2017 REVISION TABLE

(To the 2016 Electric Line Extension and Service Standards)

Figure 1

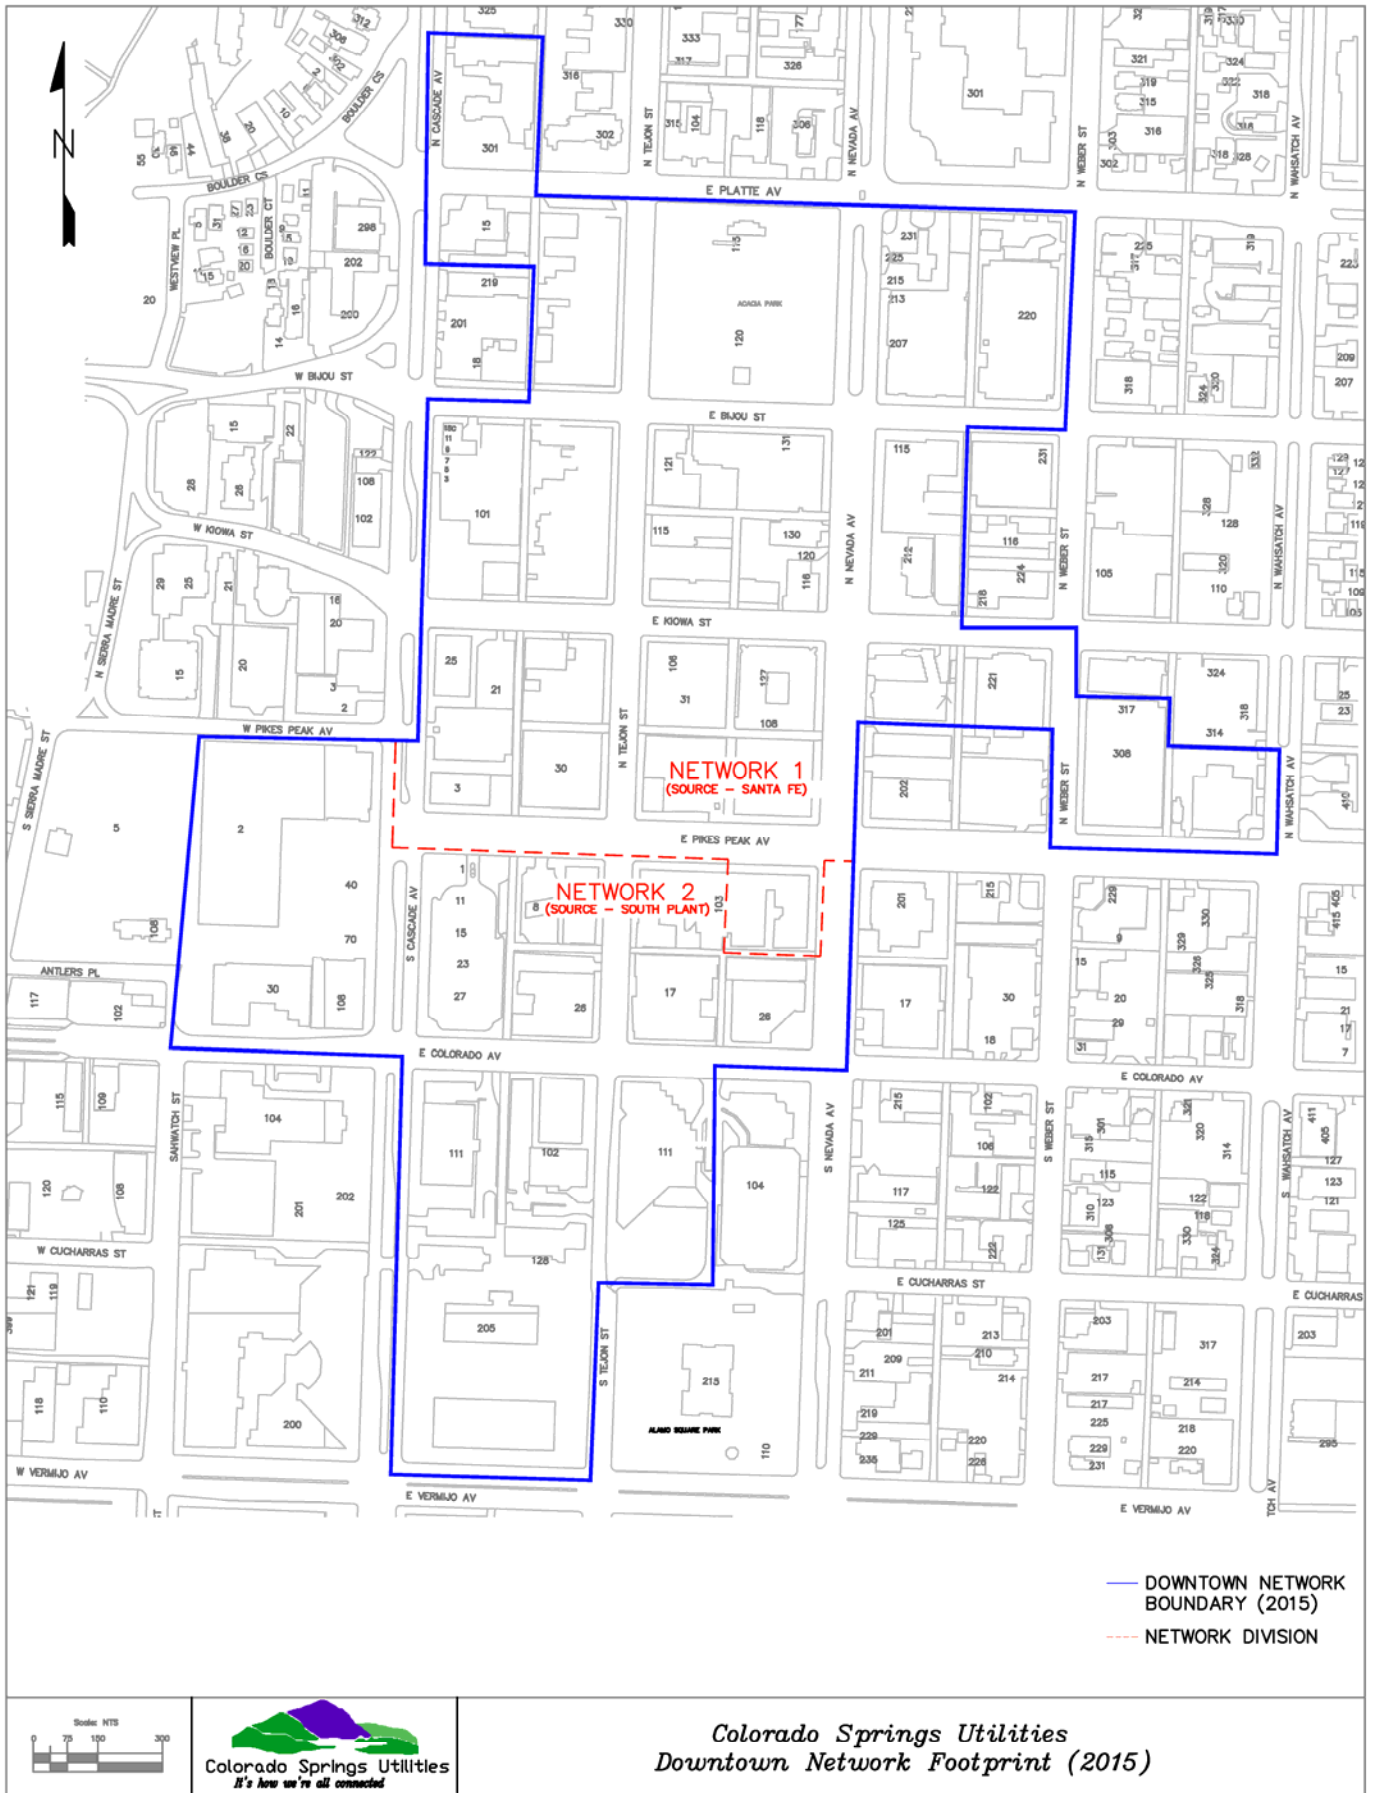
10.06 Figure 1	Commercial/Industrial Development	Updated Outlined Area for the Downtown Network Service Area.
Chapter 10 Form: 10-25	Form – Electric Load Data Form	Added Email Address field to this form.
Chapter 11	System Alteration and Conversion	11.02, 11.03, 11.05 & 11.06 – Changed “Colorado Springs Utilities” to “CSU”. 11.04 “System Improvement Program (SIP) – Major rewrite of this section.
Appendix C	Table 3	Added Siemens as approved for the 13 Terminal Meter Socket
Appendix D Drawing 14	CT Cabinet Installation	Changed minimum conduit size from 1-1/4” to 1-1/2” “ <u>1-1/2</u> ” SCH80 PVC OR GRC- 50' MAX, OR EMT- 2' MAX (SEE NOTE 7)”
Appendix D Drawing 15	Combination Metering Installation	Mike Sheehan - Changed minimum conduit size from 1-1/4” to 1-1/2” “ <u>1-1/2</u> ” SCH80 PVC OR GRC- 50' MAX, OR EMT- 2' MAX (SEE NOTE 7)” Daniel Gonzales - Add 2” minimum dimension between meter socket and other equipment.

**DRAWING 16 - TYPICAL GROUNDING/BONDING FOR
ALL SELF-CONTAINED SERVICES UP TO 480 VOLTS**

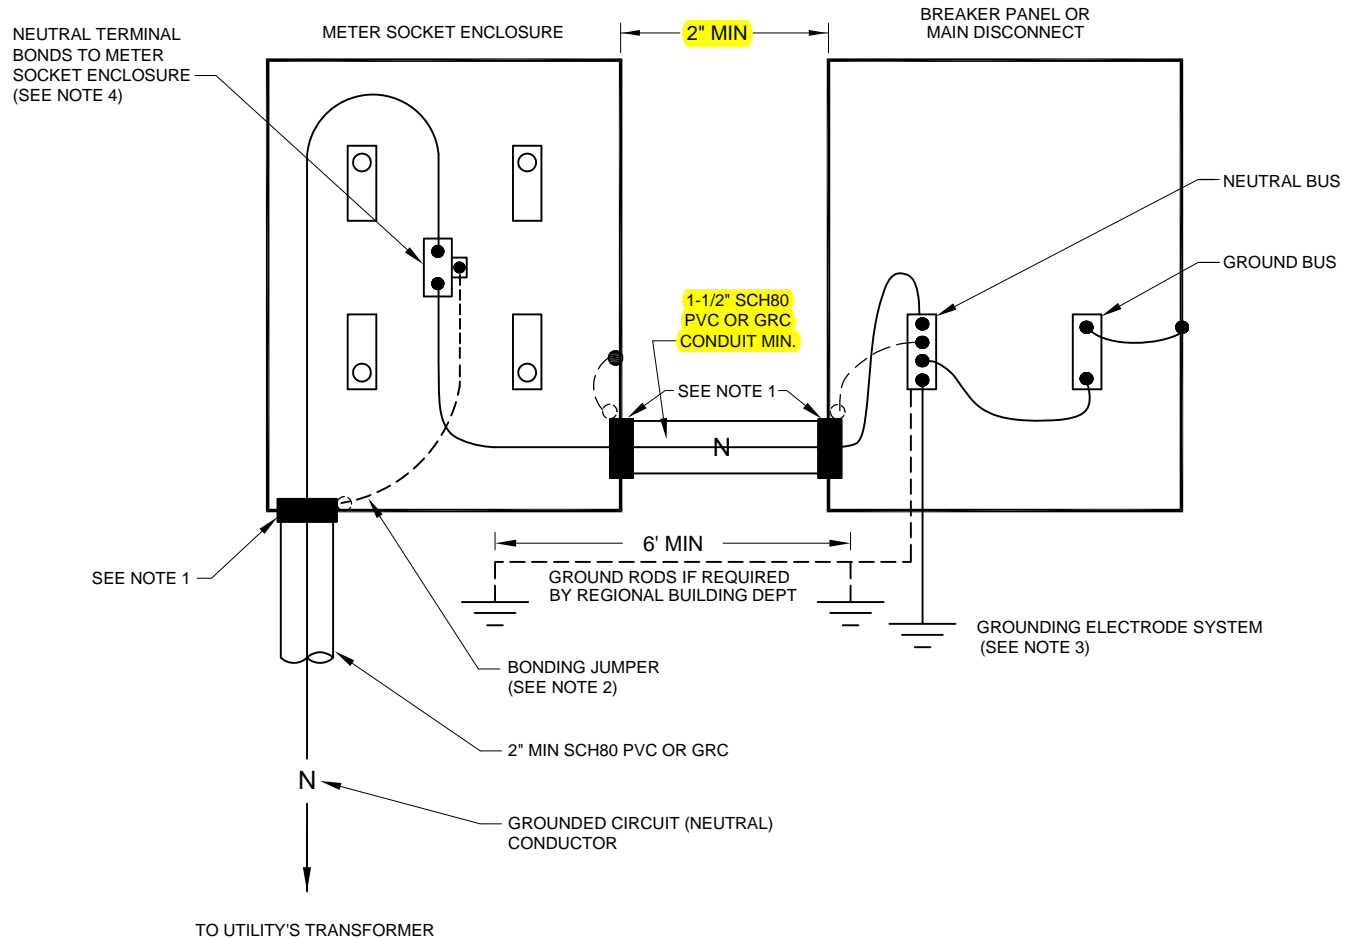
Appendix D Drawing 16	Typical Grounding/Bonding for All Self-Contained Services up to 480 Volts	Mike Sheehan – Added note “1-1/2” SCH80 PVC OR GRC CONDUIT MIN.” Daniel Gonzales - Add 2” minimum dimension between meter socket and other equipment.
Appendix D Drawing 17	Typical Grounding/Bonding for CT Cabinet and Gutter	Mike Sheehan – Added note “1-1/2” SCH80 PVC OR GRC CONDUIT MIN.” Removed note “Where metallic nipple is used, bonding of the nipple is not required.” Daniel Gonzales - Add 2” minimum dimension between meter socket and other equipment.
Appendix D Drawing 19	Outdoor Commercial Switchgear EUSERC Metering Option	Mike Sheehan – Changed minimum conduit size from 1-1/4” to 1-1/2” “ MIN 1-1/2” SCH80 PVC OR GRC” Added text to note 7 “Conduit must be contiguous from the meter socket to the switchgear CT cubicle,”
Appendix D Photo 4	Bar Type Current Transformer	Added this drawing to reference Chapter 5.04c6 for the installation of CT cabinets and relabeled old Drawing 4 to 5 and Drawing 5 to 6.

DRAWING 17 - TYPICAL GROUNDING/BONDING FOR CT CABINET AND GUTTER

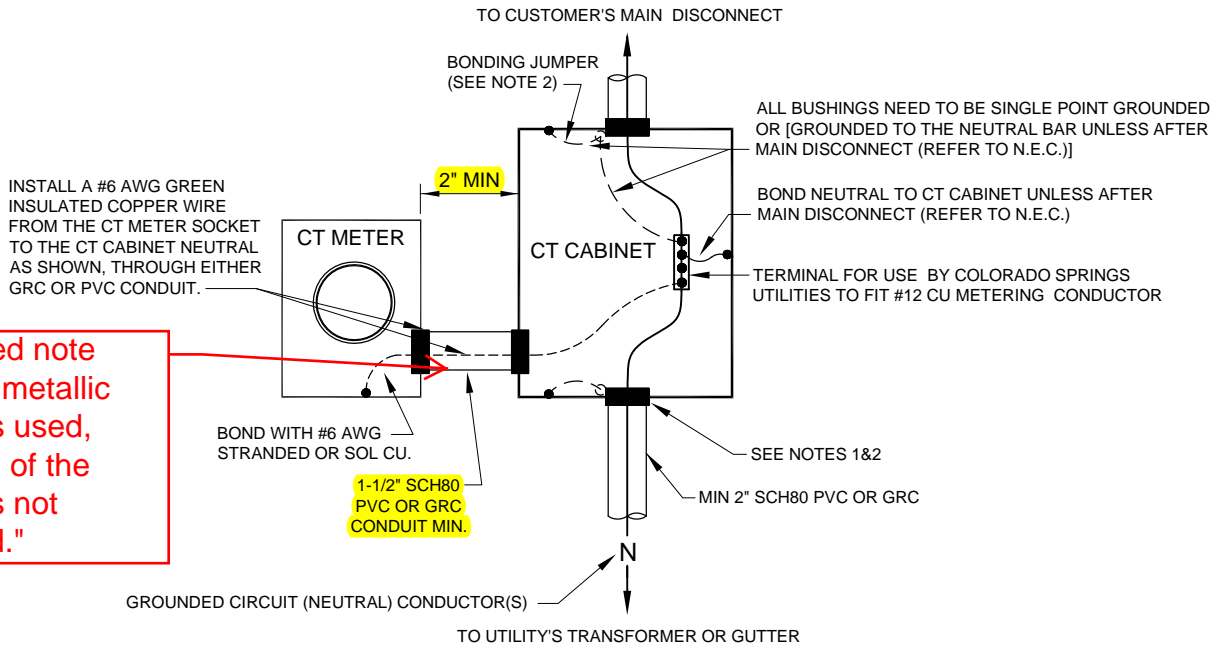
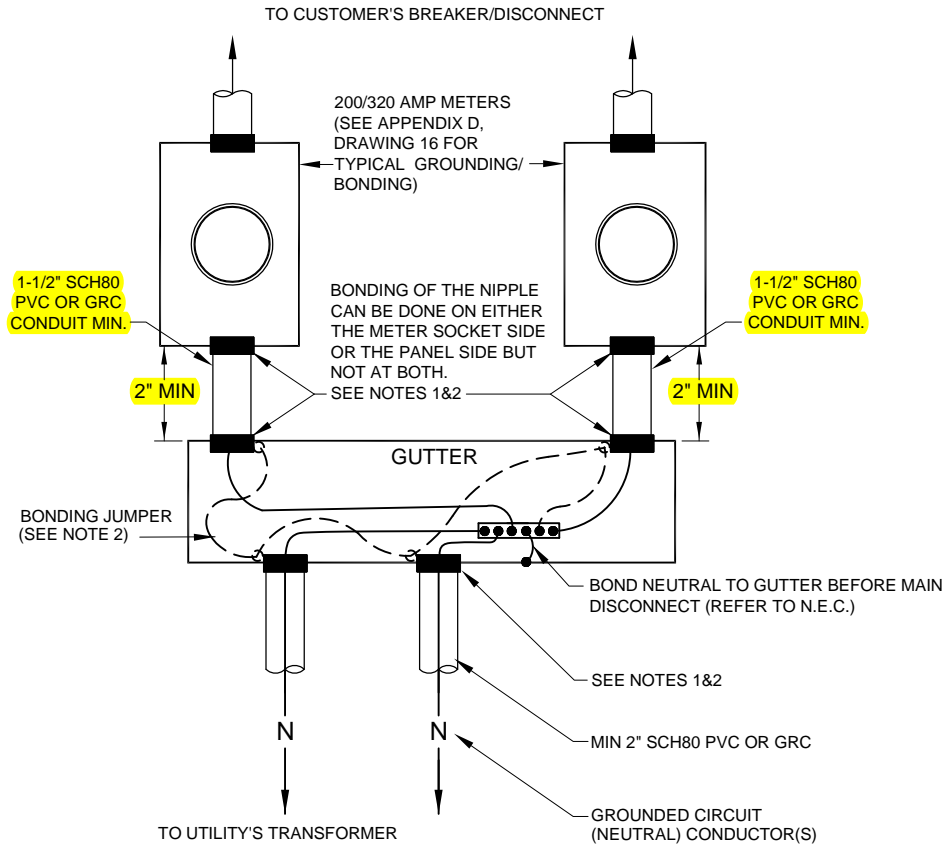
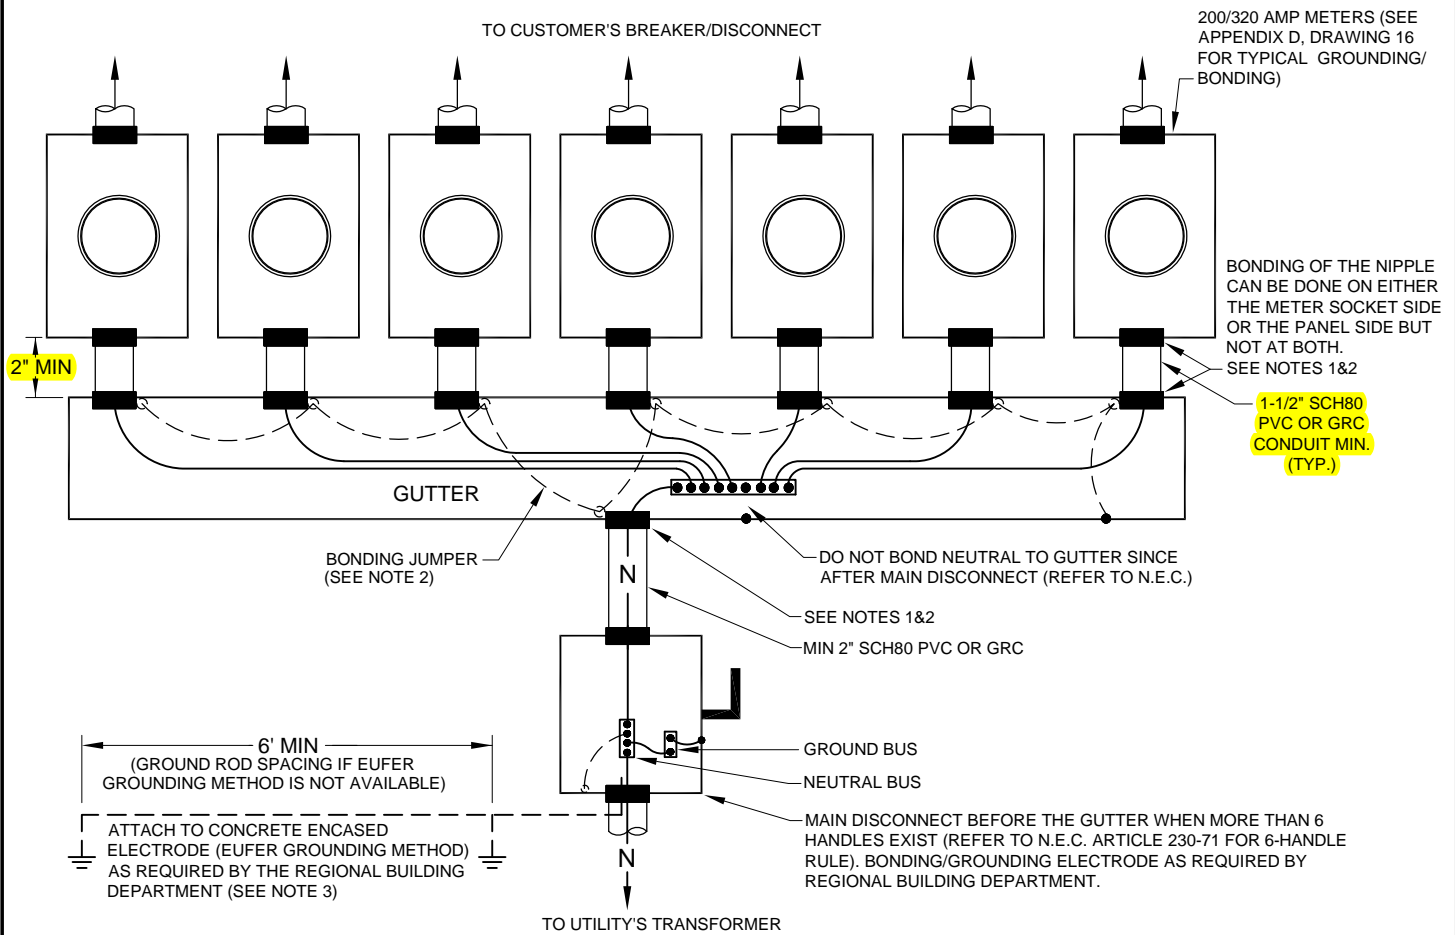
Removed note
"Where metallic nipple is used, bonding of the nipple is not required."

SINGLE PHASE, 3 WIRE, 240 VOLT

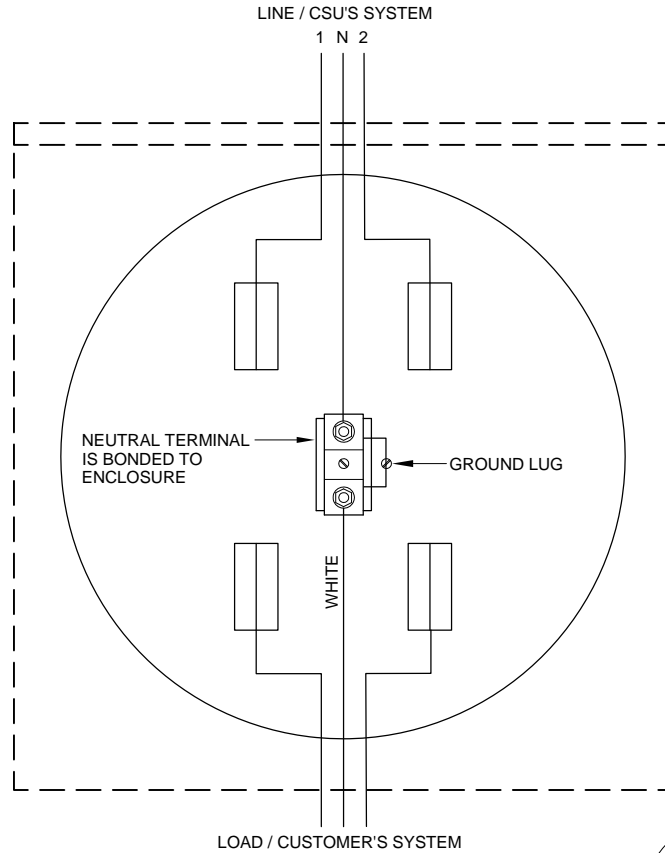
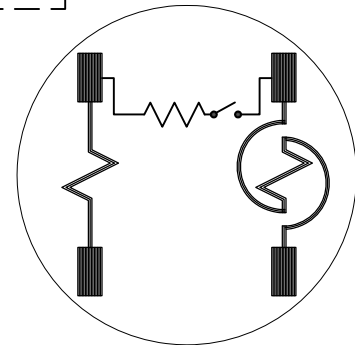
Deleted Note 5: "For overhead services, meter sockets are furnished with a hub sized as needed, available hub sizes are 1-1/4", 1-1/2", 2" and 2-1/2"."

SINGLE PHASE, 3 WIRE, 240 VOLT (320 AMP)

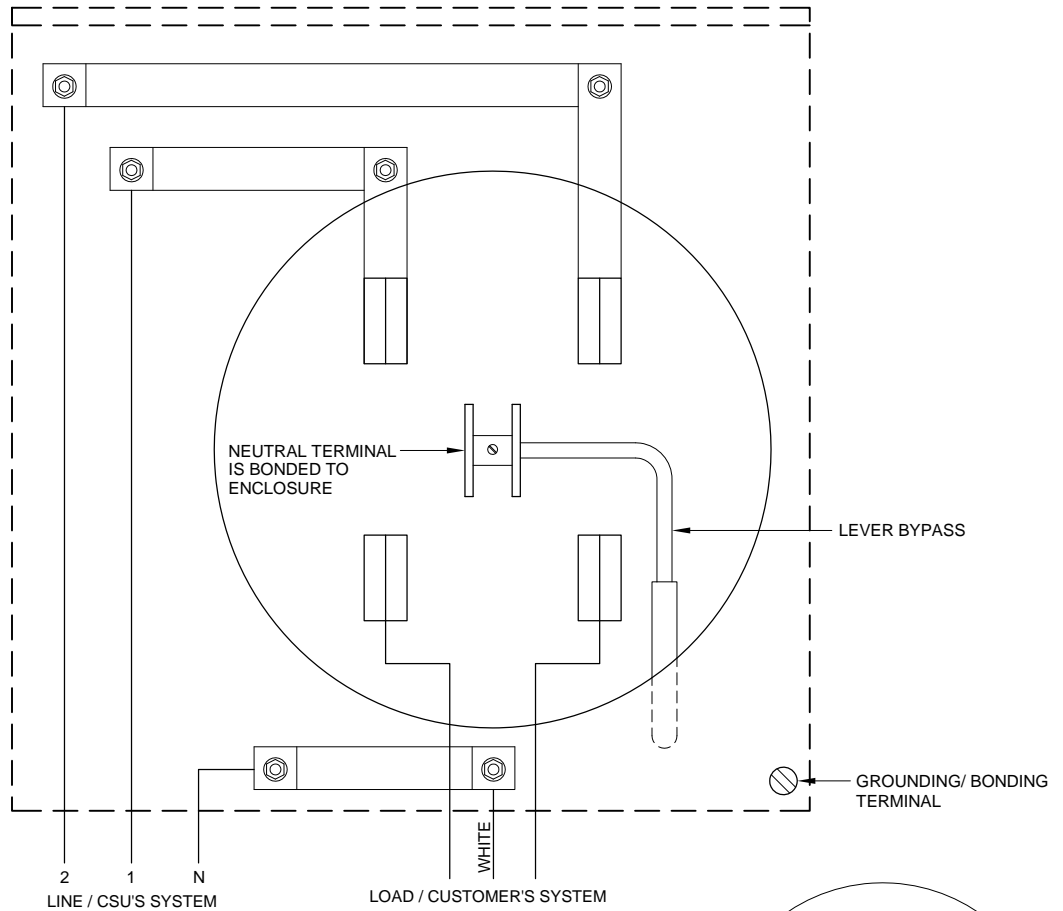
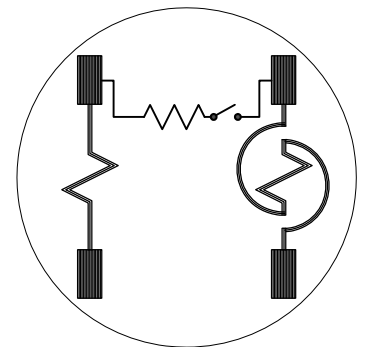
Deleted Note 5: "For overhead services, meter sockets are furnished with a hub sized as needed, available hub sizes are 1-1/4", 1-1/2", 2" and 2-1/2"."
